L190-E990466-00-D

ENGINEERING CHANGE REQUEST (ECR)

CUSTOMER DRAWING NO. *D172465*

DRAWING TITLE *BSC CHAMBER 10.5" NOZZLE PORT CONFLUENT COVER*

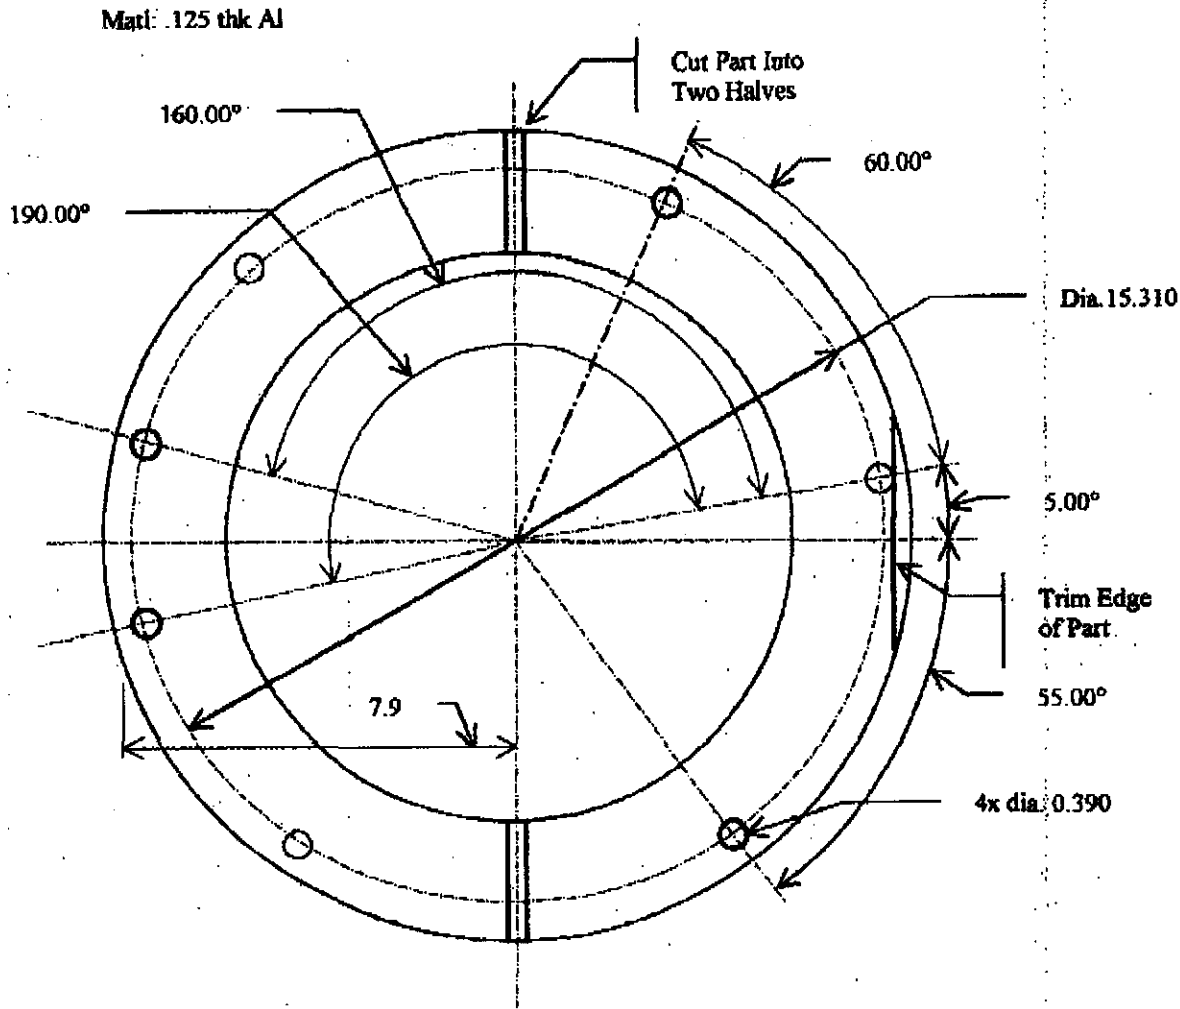
Change orientation of A Mods as indicated on attached drawing; trim only one side of part; additional holes needed

To accommodate orientation of Chamber Nozzle Port; minimize mods; add holes to allow centering jig connection

Make following modification to existing part:

1. Add four through holes at indicated positions. Base orientation on existing holes.
2. Trim segment from edge of part as indicated
3. Cut part into two halves, position not critical.
